File: 39T-14505/OZ-8426
Planner: L. Mottram

TO:	CHAIR AND MEMBERS PLANNING AND ENVIRONMENT COMMITTEE
FROM:	GEORGE KOTSIFAS, P.ENG. MANAGING DIRECTOR, DEVELOPMENT & COMPLIANCE SERVICES AND CHIEF BUILDING OFFICIAL
SUBJECT:	APPLICATION BY: SIFTON PROPERTIES LIMITED RIVERBEND SOUTH SECONDARY PLAN APPLICATION FOR APPROVAL OF DRAFT PLAN OF SUBDIVISION OFFICIAL PLAN AND ZONING BY-LAW AMENDMENTS PUBLIC PARTICIPATION MEETING ON MARCH 23, 2015

Proposed Draft Plan of Subdivision (Phase 1)

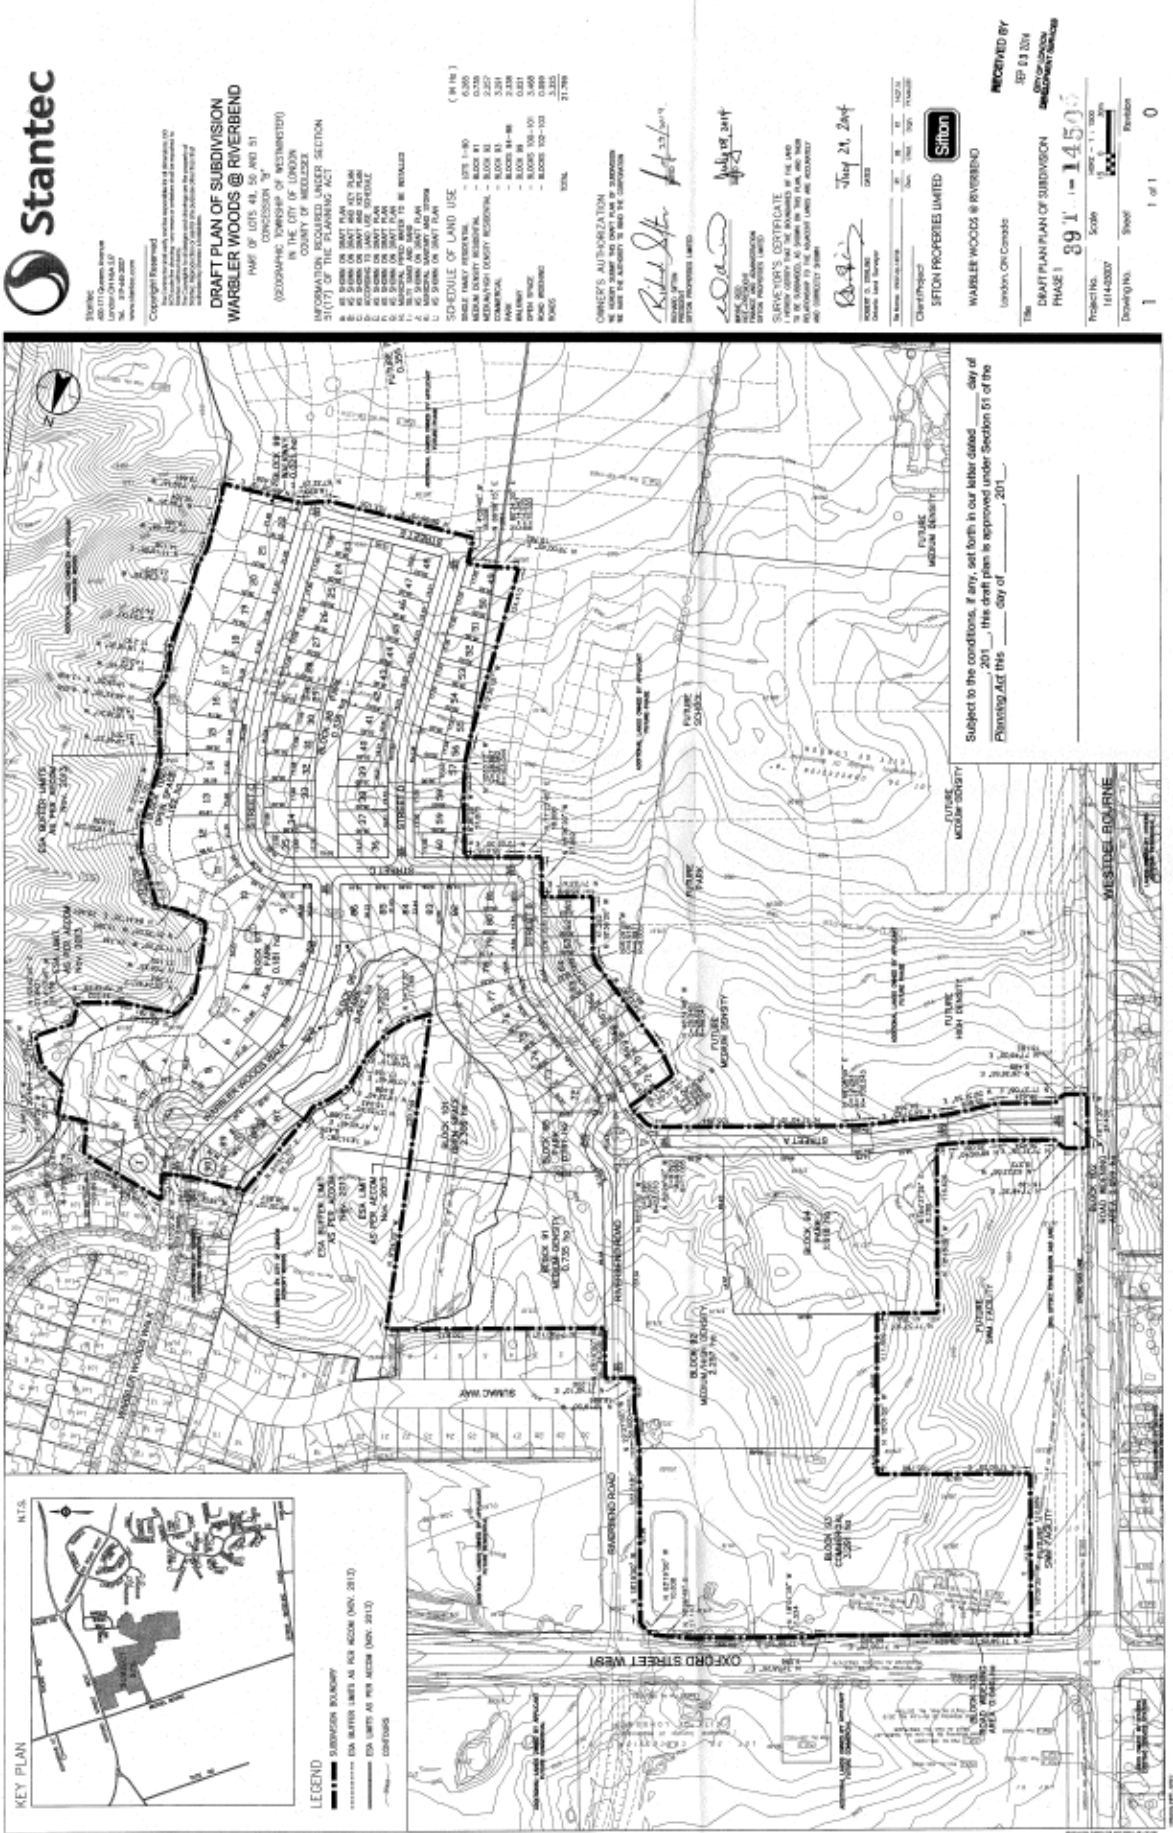
- The plan proposes a restricted turn access on Oxford Street West at the commercial Block 93. This access must be positioned in a location that will permit enough left turn storage for turn lanes on Oxford Street West at both Westdel Bourne and Riverbend Road. Any access to Westdel Bourne for this block will also be problematic due to the close proximity to Oxford Street West and the needs for the storm water management channel. A holding provision for access should be applied to Block 93 until the access location is determined satisfactory to the City Engineer.

Development Services – Engineering recommends that lands adjacent to the west limit of the draft plan abutting Westdel Bourne (eg. future SWM facility) be included in the draft plan to address municipal servicing issues and land dedication needs. Red-line revisions to the proposed draft plan are recommended, as follows:

- i) Include all lands to the west of this plan abutting Westdel Bourne (eg. future SWM Facility) and identify appropriately size proposed SWM Blocks identified in the approved Tributary 'C' Municipal Class EA

- ii) Identify and provide all road widening blocks
- iii) Provide 0.3 metre reserves along Westdel Bourne, Oxford Street West, and any open road allowances (eg. shown on red-lined plan)

- iv) Revise draft plan to remove all information that is not pertinent (eg. median on Street 'A')
- v) Identify Union Gas easement
- vi) Revise road widths of the following:

- Street 'C', Street 'D' and Street 'E' to be revised to 19.0 metre right-of-ways
 - Street 'B' to be revised to 20.0 metre right-of-way
- vii) Identify all daylighting triangles

- viii) Revise the location of Street 'A' should the sight decision distance be determined to be inadequate
- ix) Identify a 30 metre taper on Riverbend Road, south of existing Riverbend Road

- *Proposed redline revision to the submitted plan include*
 - *Park Block 94 should be enlarged to include the frontage along Street A to provide for the multi-use pathway connecting to the park block on the east side of Riverbend Road. Multi-use pathways are not to be included within the boulevards of municipal streets; and*

- *The frontage of Park Block 97 on Street C should be increased in size to a minimum of 15 metres to provide safe visible access to the pathway system.*

Staff response: *The recommended secondary plan, red-line revisions, holding provisions, and conditions of draft plan approval have captured the above requirements for wastewater, stormwater, water and transportation (Conditions #22 to #112).*

Staff response: *The recommended secondary plan, red-line revisions, and conditions of draft approval have captured the above requirements (Conditions #13 to #21).*
